HISTORIC PRESERVATION COMMISSION

SUBJECT: Historic Area Work Permit #623731, for demolition of non-historic addition and construction of second story addition and screened porch

MONTGOMERY COUNTY HISTORIC PRESERVATION COMMISSION
STAFF REPORT

Address:	24 West Kirke, Chevy Chase	Meeting Date:	2/13/13
Resource:	Contributing Resource Chevy Chase Village Historic District	Report Date:	2/6/13
Applicant:	Michael and Carol McGarry	Public Notice:	1/31/13
Review:	HAWP	Tax Credit:	No
Case Number:	35/13-13E	Staff:	Karen Theimer Brown

WEST ELEVATION
 1/4" = 1'-0"

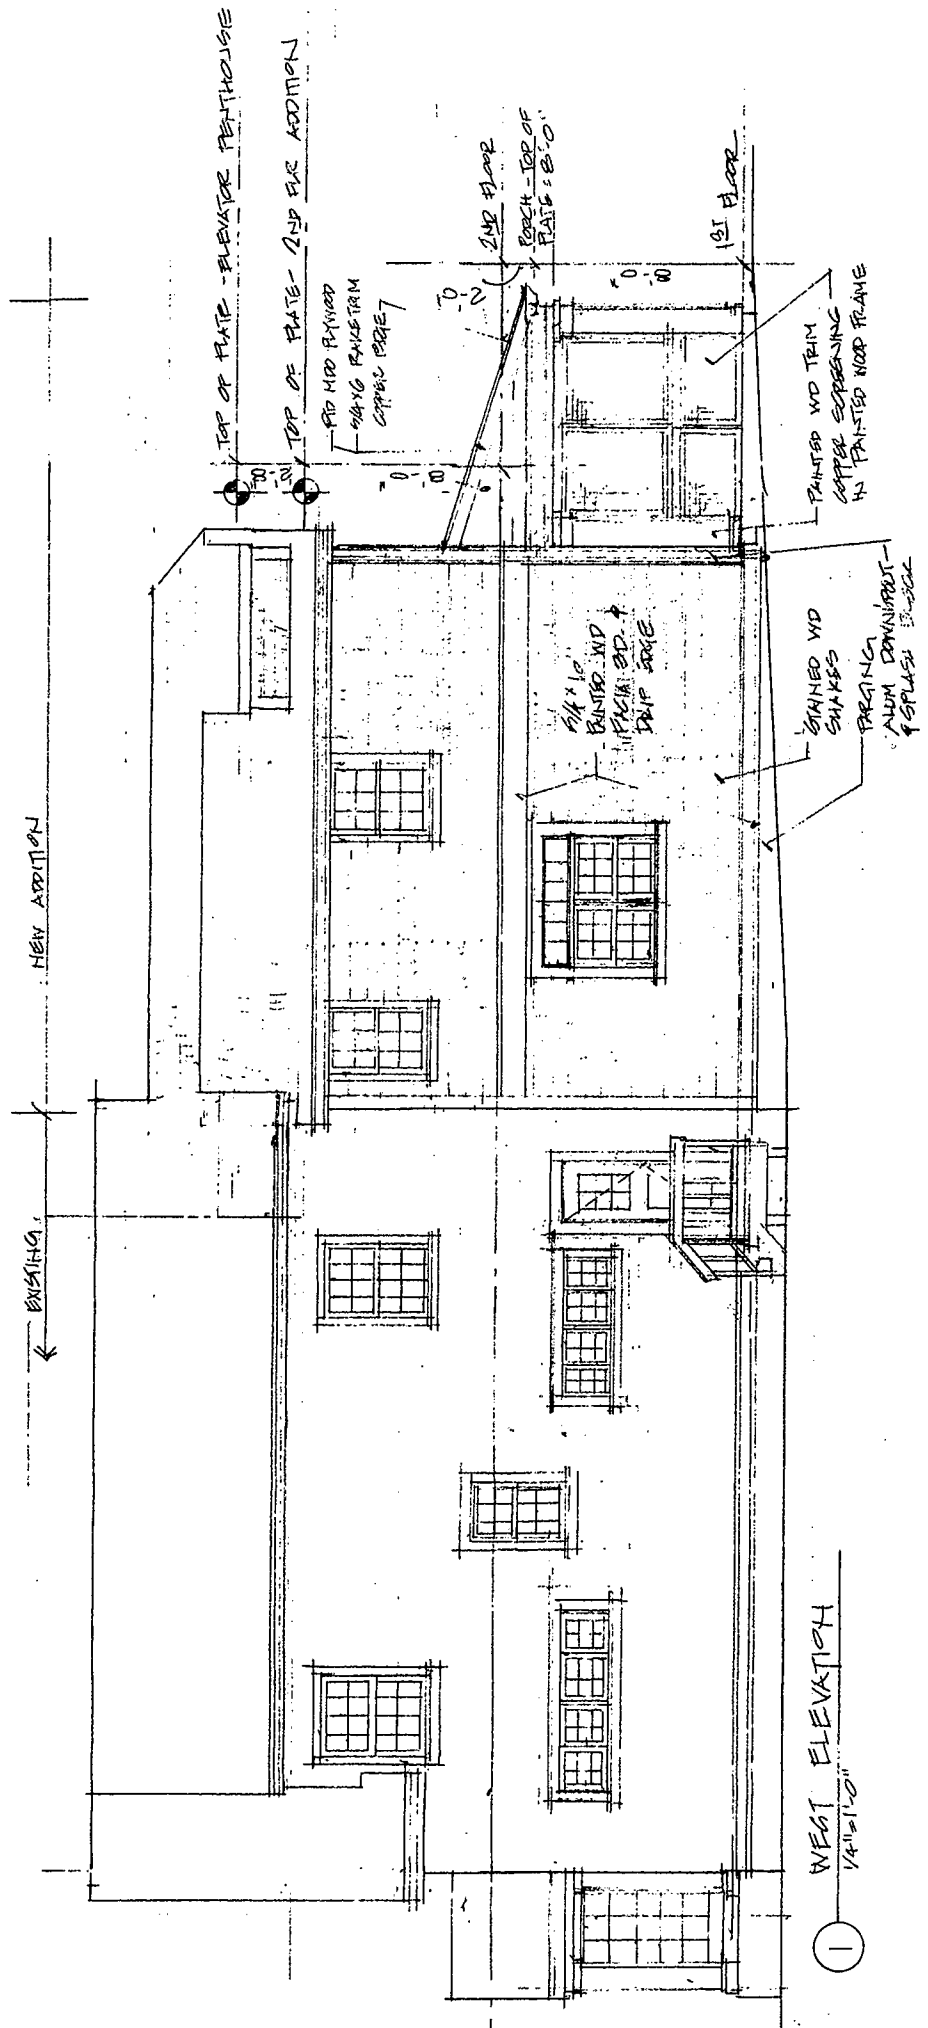
The proposed two-story addition is 26' 4" x 16' 4". The proposed one-story screened in porch measures 10' x 16' 4" and is attached to the rear addition. The addition conforms to the rear and side setback requirements. The addition is set in on the west elevation (right side) 8" in order to differentiate from the historic block and preserves the original corner of the house.

NORTH ELEVATION

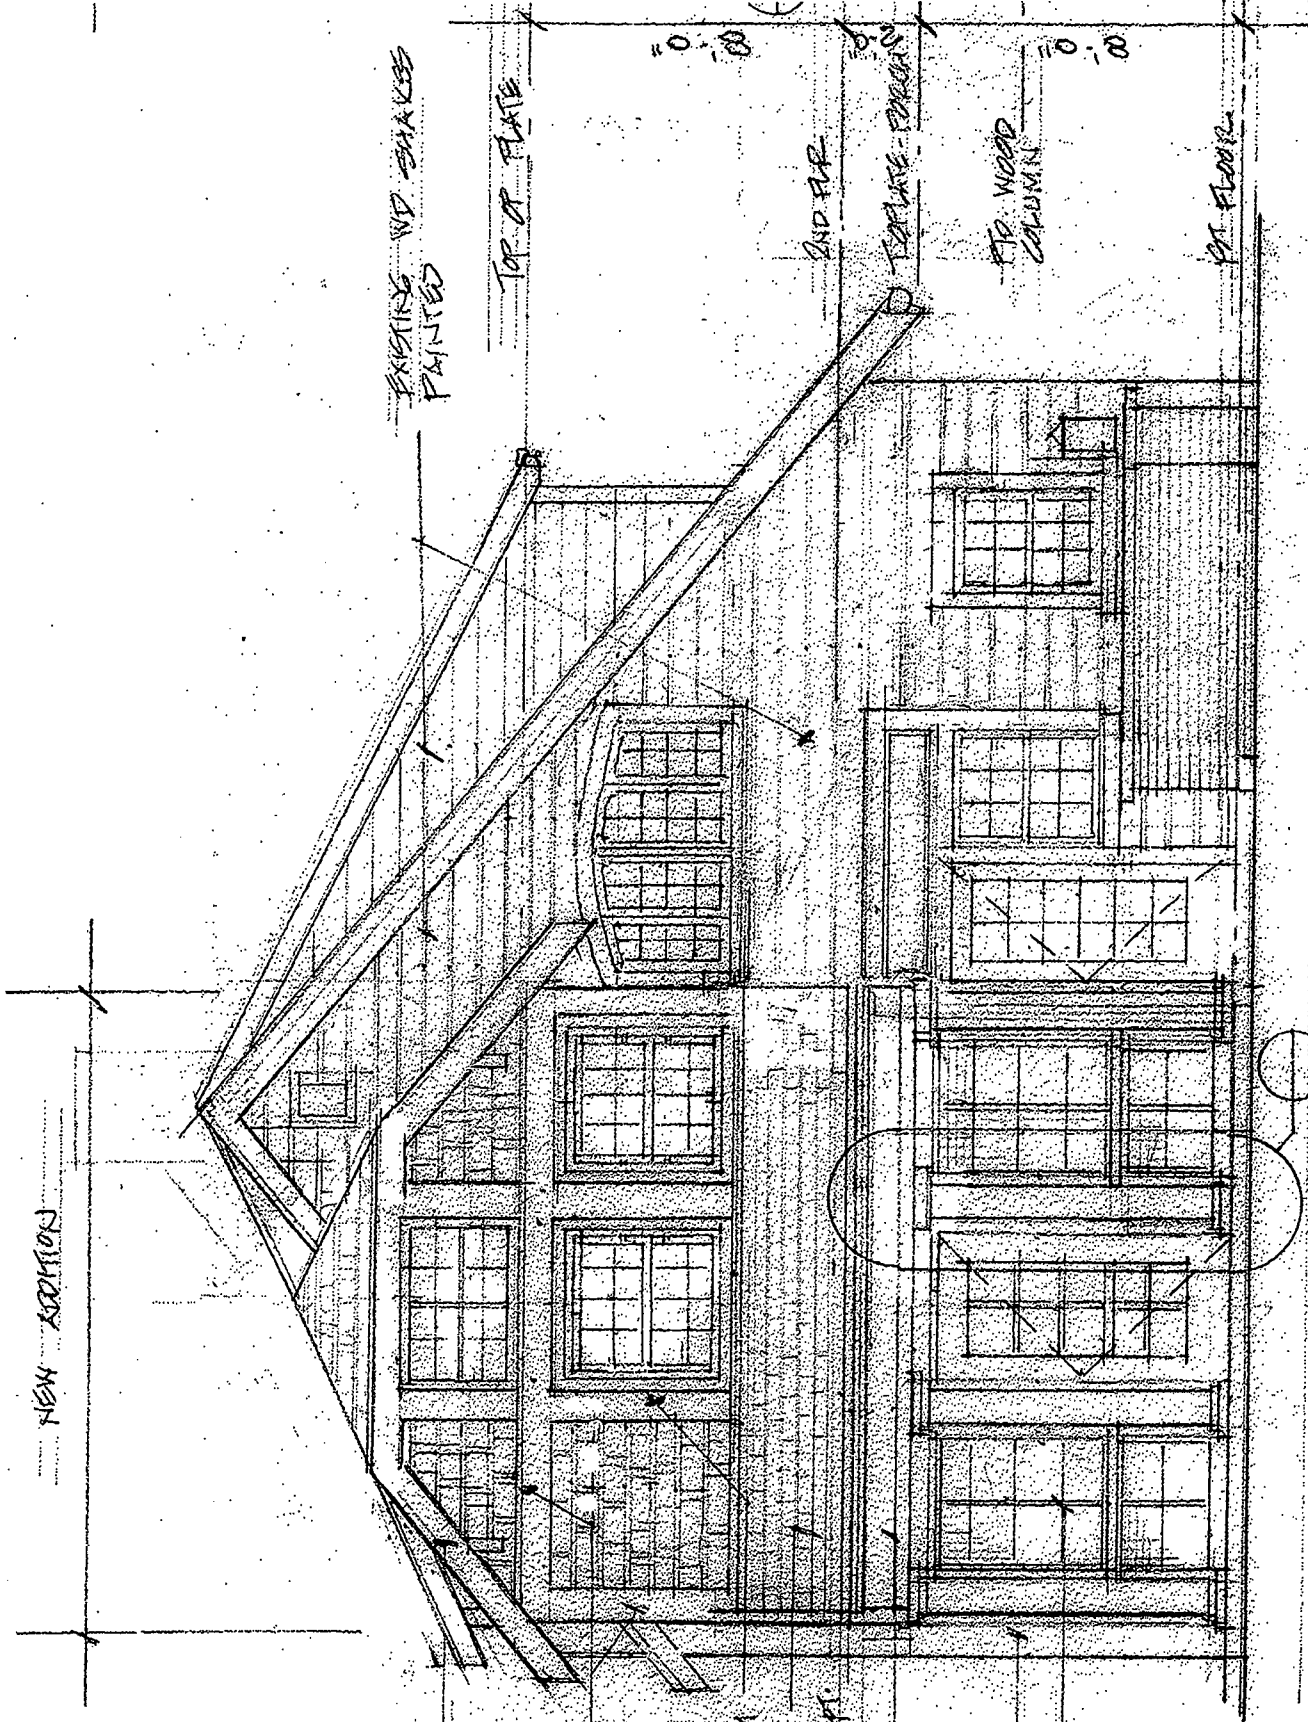
In a previous iteration of this application, the roofline of the addition was visible from the public right of way. To address this issue, the design was modified from a gable roof to a clipped gable. The roofline of the addition is lower than the historic block and is subordinate to the original mass. The revised design preserves the historic front façade and the visibility of the top of the plate of the elevator penthouse from the public right of way is diminished.
